SUBJECT: Responds to 840725 request for addl info re isolation devices used within reactor protection sys & control sys failures due to high energy line breaks.

Subject: Palo Verde Nuclear Generating Station (PVNGS)  
Units 1, 2 and 3  
Docket Nos. STN-50-528/529/530  
File: 84-056-026; G.1.01.10

Responses to NRC Questions Concerning Isolation  
Devices Used in the Reactor Protective System

Responses to NRC Questions Concerning  
Control System Failures Due to  
High Energy Line Breaks (HELBs)

FIGURE -1

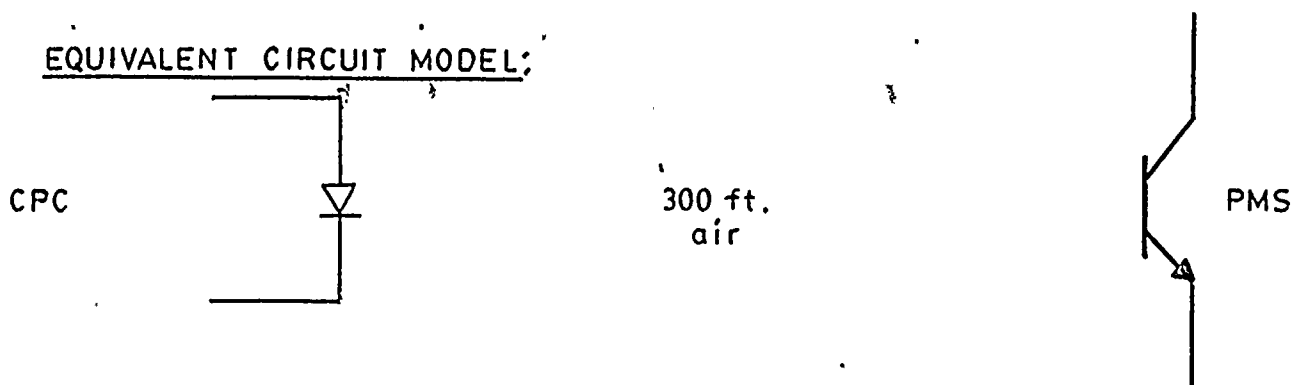
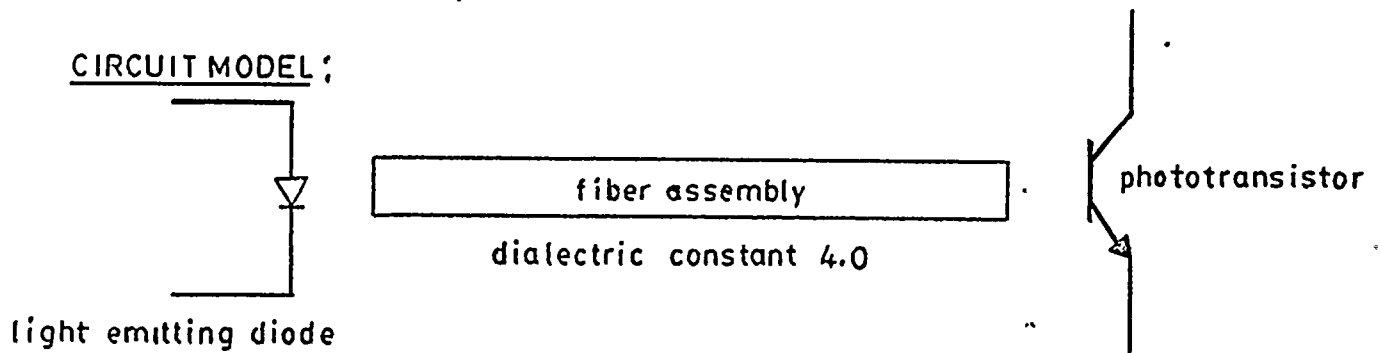
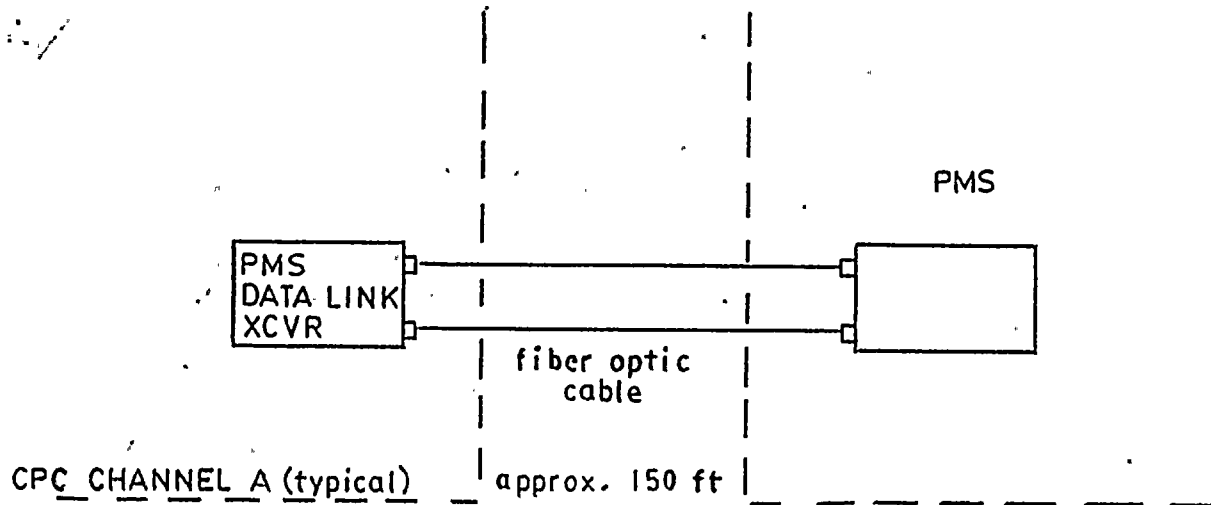
1. Detailed information (including drawings) to describe the physical implementation of the subject isolation devices into the reactor protection system design. This should include specific information on the physical design and electrical characteristics of the isolation device itself.

- 
2. A description of the specific testing or analyses performed to demonstrate that the device is acceptable for its application. This description should include a discussion of the system mock-up considered including elementary drawings where necessary to indicate the design configuration and how maximum credible faults (including continuous phase-to-phase short circuits, phase-to-ground short circuits, and the application of continuous external high voltages) and voltage transients were applied or considered.

Response: The CPC/PMS Data Link System installed at Palo Verde Units 1, 2 and 3 is depicted in the figure on page 14. The four CPCs and the two CEACs in the DNBR/LPD Calculator System communicate individually to the Plant Monitoring System (PMS). The fiber optic modules at each end of the interface function as transducers; converting electrical signals to light pulses at the transmitting end, a CPC or a CEAC, and converting the light pulses to electrical signals at the receiving end, the PMS. Each of the six interfaces is accomplished over two fiber optic cables (reference the attached Pirelli data sheet (type S125C1)). The installed cable length varies with the channel involved but each is approximately 150 feet. The construction of the optic cable is such that the cable contains no electrically conductive material. The cable, rather than the modules, is the isolation medium. From an electrical point of view, it is as if the fiber optic cable were not even present.

Response: An analysis of the isolation characteristics of the data link is provided starting on page 5:

Physical Installation

Acceptance Criteria: A. Separation of 6" of air from R.G. 1.75

A. Separation distance calculation:

Conclusion:  $D_S$  is greater than 6 inches, therefore  
Criterion A is met with a margin of  
greater than 100.

B. Maximum credible fault calculation

Therefore, Criterion B is met and the isolator is qualified.

D-SYS80-414-472

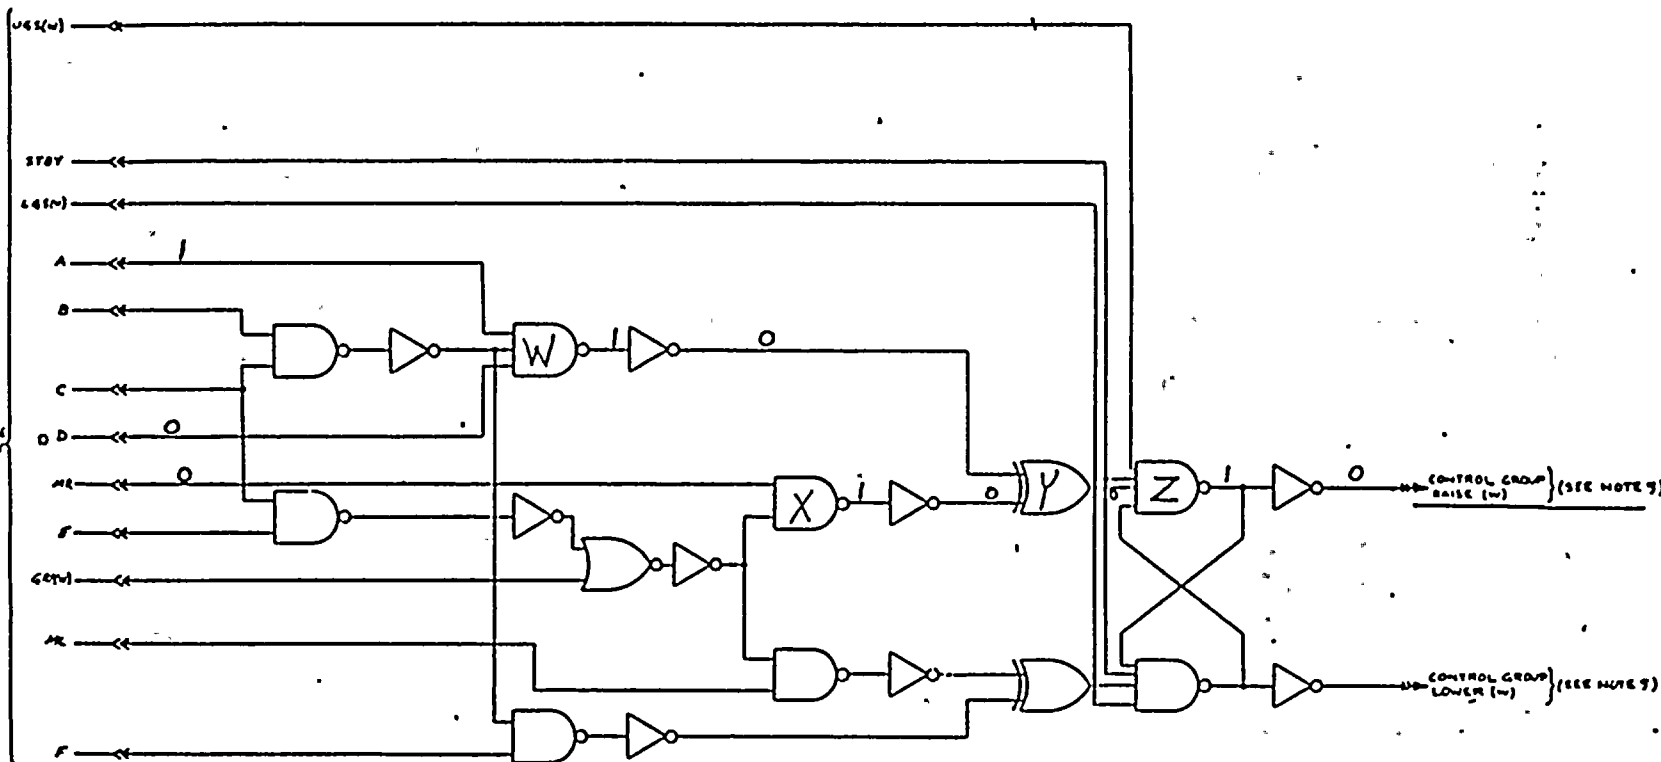
1. Detailed elementary drawings and electrical schematics to show the interaction of the Reactor Regulating System (RRS) and Steam Bypass Control System (SBCS) output signals with the Control Element Drive Mechanism - Control System (CEDMCS). This should clearly show the interface of the SBCS Automatic Withdrawal Prohibit (AWP) signal with CEDMCS which is to be used to block the RRS demand for withdrawal of control element assemblies (CEAs). The drawings should be highlighted and/or annotated as necessary for clarity.

- 
2. Information to verify that, should the RRS demand for withdrawal signal exist, a subsequent SBCS AWP signal will block the RRS demand signal and will result in the discontinuation of CEA withdrawal. Drawings to be provided as part of item 1 above should clearly show this. Again, please highlight and/or annotate where necessary.

Response: The event scenario of concern is the failure of the SBCS such that a quick open signal is generated in combination with the RRS generating a CEA withdrawal signal during a steam line break inside the containment building. This scenario is being reviewed because of the potential increase in positive reactivity insertion above that reported in the PVNGS FSAR and the impact on the consequences. The following discussion explains why the combined actions of the SBCS and RRS need not be considered since an AWP signal will block a CEA withdrawal signal from the RRS, or terminate an automatic withdrawal if the withdrawal is already in progress. Enclosure (A), Page 6, is the CEDMCS Group Raise/Lower Logic Diagram.

The SBCS generates an AWP signal whenever a SBCS demand for opening the turbine bypass valves exists. This signal is generated for both the quick open and the modulate open signals. The AWP signal is sent to the CEDMCS (Input "D" on Enclosure (A)).

The RRS may generate an Automatic Raise (AR) signal due to a normal or faulted input. This signal is sent to the CEDMCS (input "A" on Enclosure (A)). The RRS generates other signals which do not impact this discussion since they do not result in the uncontrolled withdrawal of CEAs.

If an AWP is generated and the RRS is requesting CEA withdrawal then the inputs to the CEDMCS will have the following values; A = "1", D = "0", and MR = "0" (no operator action). Tracing these inputs through the CEDMCS logic diagram (Enclosure (A)) yields the following:

- A. Since the AWP signal, input D, is "0", the output of NAND gate "W" will be 1, regardless of the value of inputs B and C.
- B. The output of NAND gate "X" will be 1 since the MR input is "0" regardless of the value of the other input to the gate.
- C. The output of Exclusive OR gate "Y" will be "0" since both of its inputs will be "0". Both of the NAND gate outputs have been inverted by the amplifier/inverters.
- D. The output of NAND gate "Z" will be 1, since the output of the Exclusive OR gate is "0", regardless of the other inputs to the NAND gate.
- E. Finally, the output of the CEDMCS logic is "0" for the "control group raise" portion of the diagram. The "control group lower" portion is not of interest since CEA withdrawal is the malfunction of concern.

From the above discussion, it can be concluded that in the presence of both an automatic raise signal from the RRS and an AWP signal from the SBCS, there will be no "control group raise" signal from the CEDMCS. As a matter of interest, the override of the RRS request occurs in what has been labeled NAND gate "W" of the attached diagram.

Response: The response to question (1) applies to a CEA withdrawal in progress when an AWP signal is generated. The logic is not latched. When signal "D" is zero, the automatic withdrawal will be terminated.
